# Decision Report

**Works Approval Number** W6213/2019/1

**Premises** Richgro Bannister Composting Facility  
Lot 68 on Deposited Plan 36563  
Certificate of Title Volume 2798 Folio 962  
BANNISTER WA 6390

**Date of Report** 26 June 2020

Figure 1: Leachate dam specifications

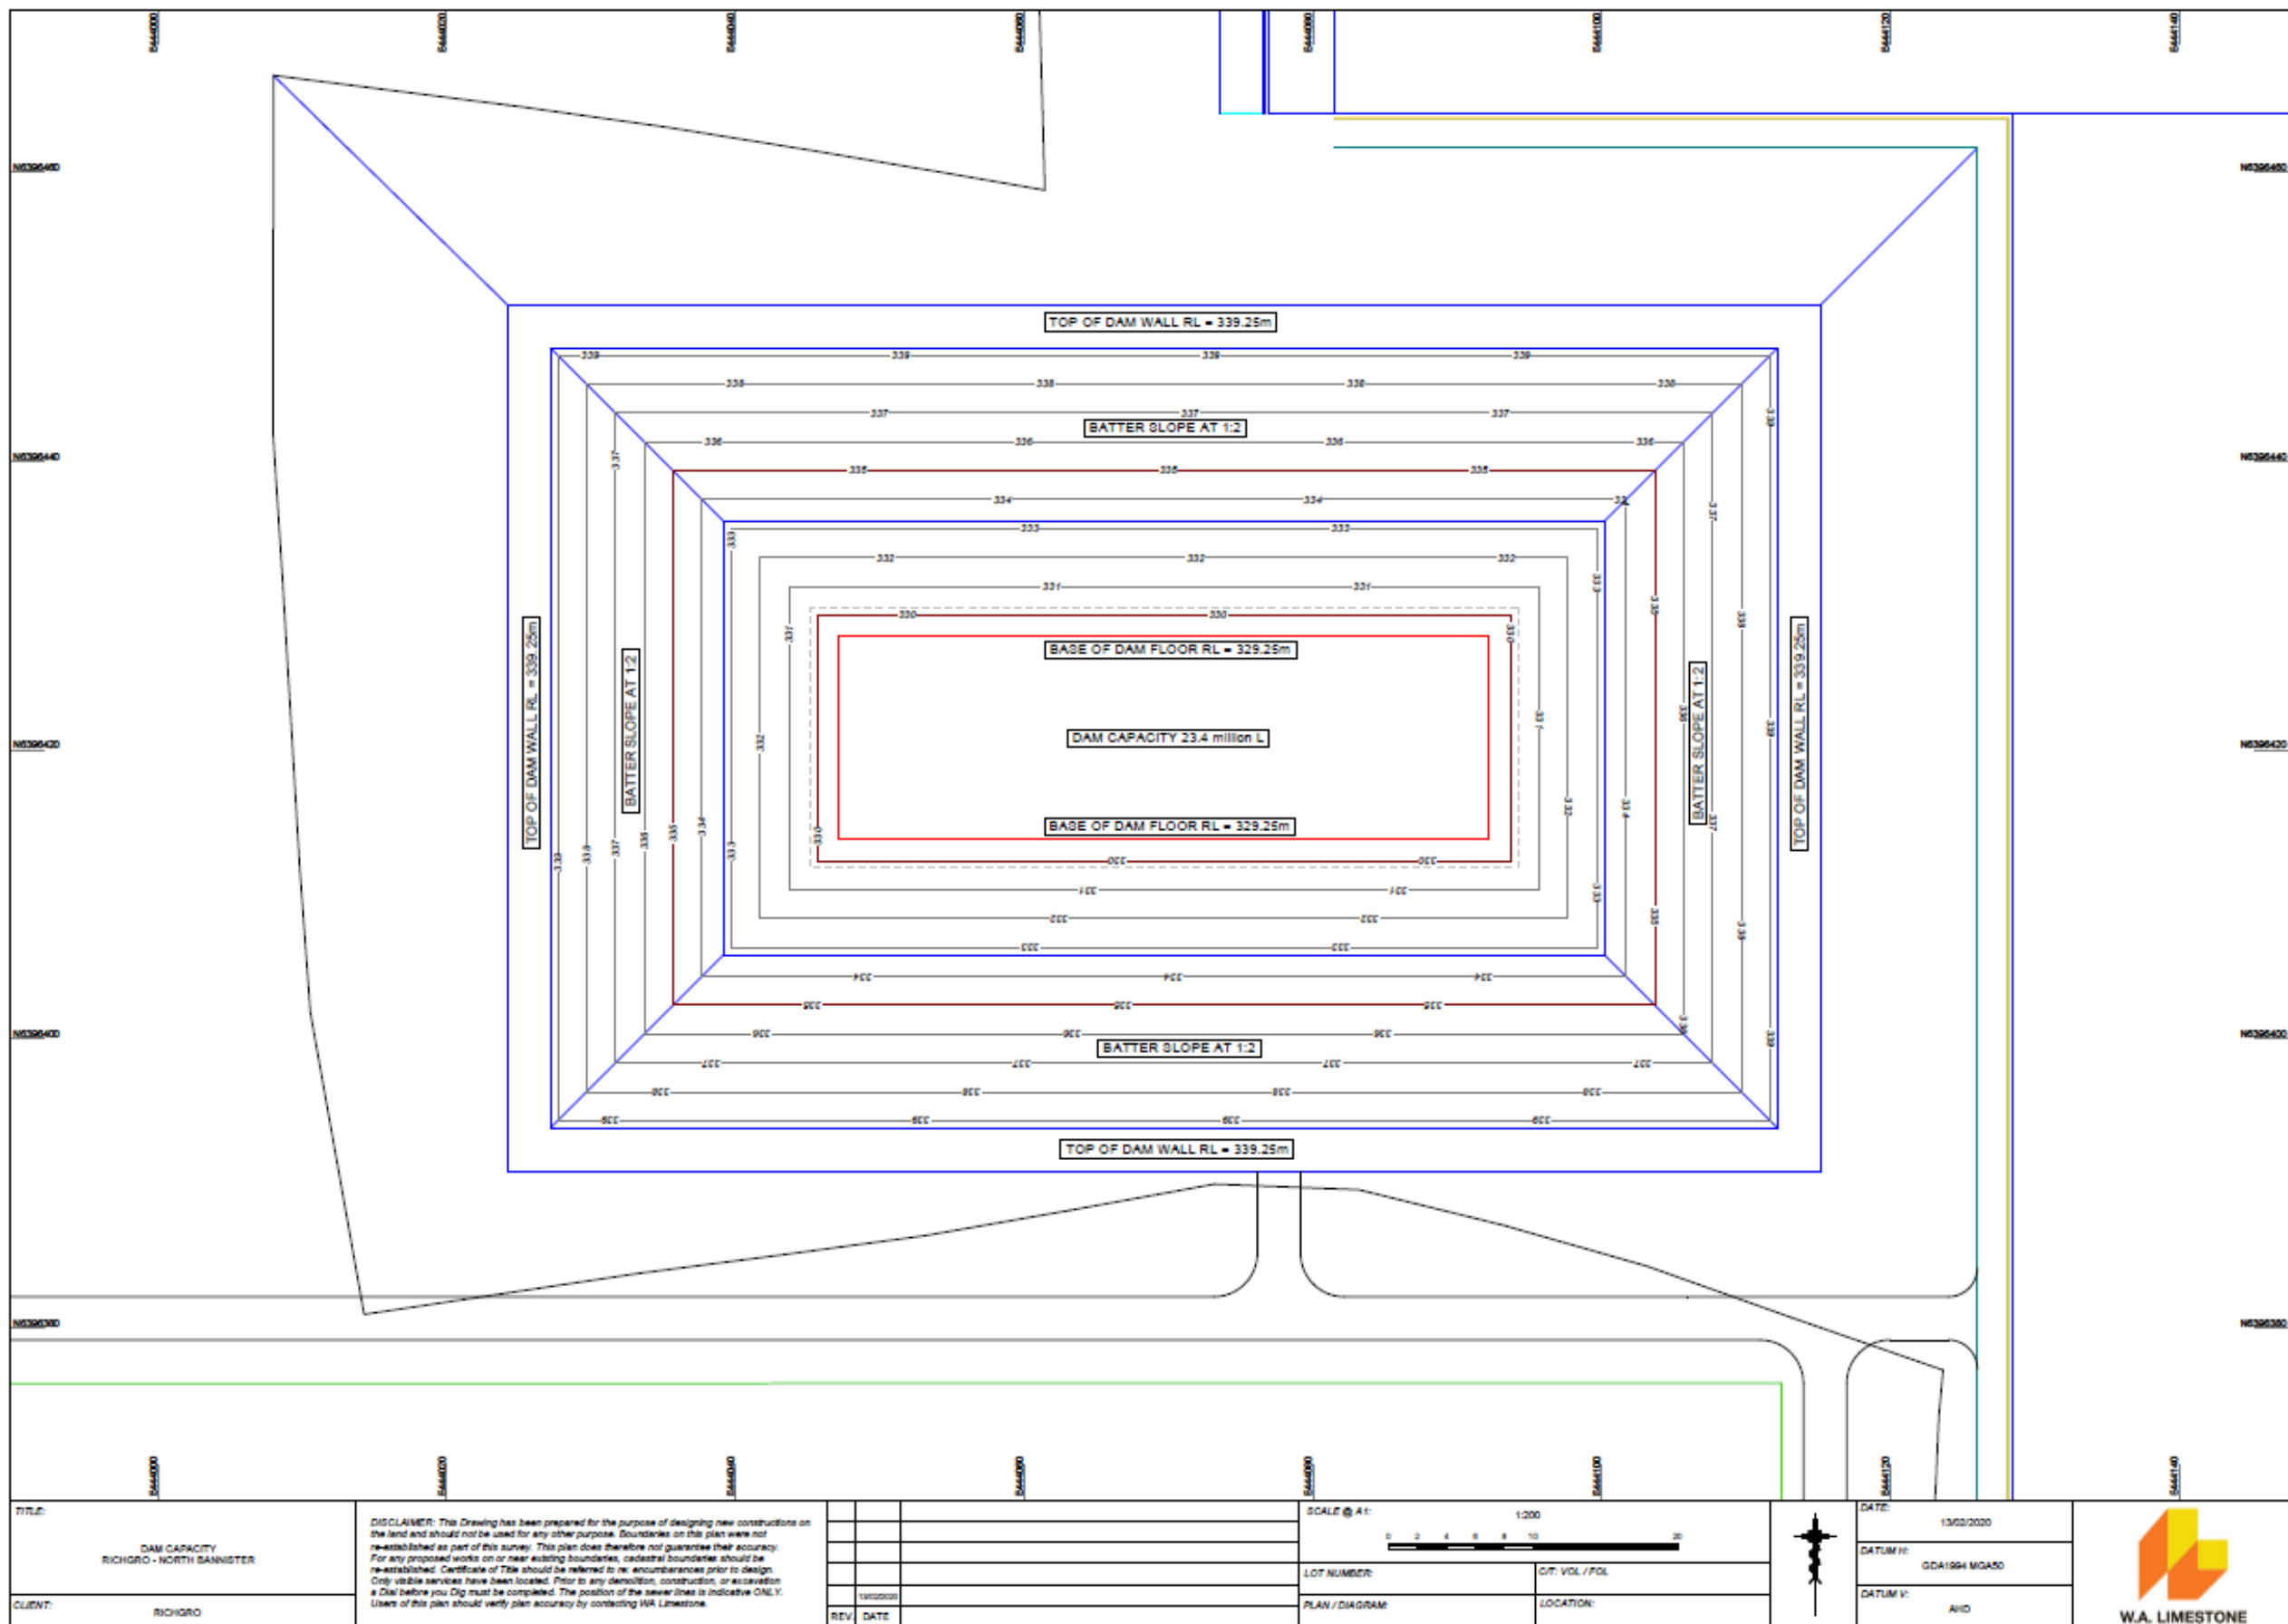
As part of the amendment application, the works approval holder has requested that the depth of the pond be increased to 10 m, 5 m deeper than the originally proposed 5m deep pond, with no change to the pond surface area (Figure 1: Leachate dam specifications). This increase in size followed the discovery that deeper excavation was possible during the construction process. The works approval holder has also requested a reduction in the required 1000 mm freeboard to 300 mm. This request has been made on the basis that the pond now has a significantly increased leachate containment capacity. The works approval holder has provided advice to DWER that the capacity of the deepened pond has been calculated to be 23,400 KL.

As part of the assessment of the amendment application, the Department prepared additional water balance calculations for the revised leachate pond volume and liquid waste throughput under several minimum freeboard scenarios. On the basis of these calculations, the works approval holder was requested to provide further details on what measures will be implemented at the premises to ensure that the freeboard of the leachate pond is maintained, and no overtopping will occur. In response, the works approval holder has provided a water balance prepared by consultant Bowman & Associates Pty Ltd. The maximum volume of runoff associated with a 72-hour storm event was calculated to be approximately 9,000 KL. Given the increased capacity of the pond, it was determined by the consultant that the pond, with reduced freeboard, has a sufficient volume to contain stormwater runoff without overtopping. On this basis, the delegated officer has deemed that the requested reduction in required freeboard is justified.
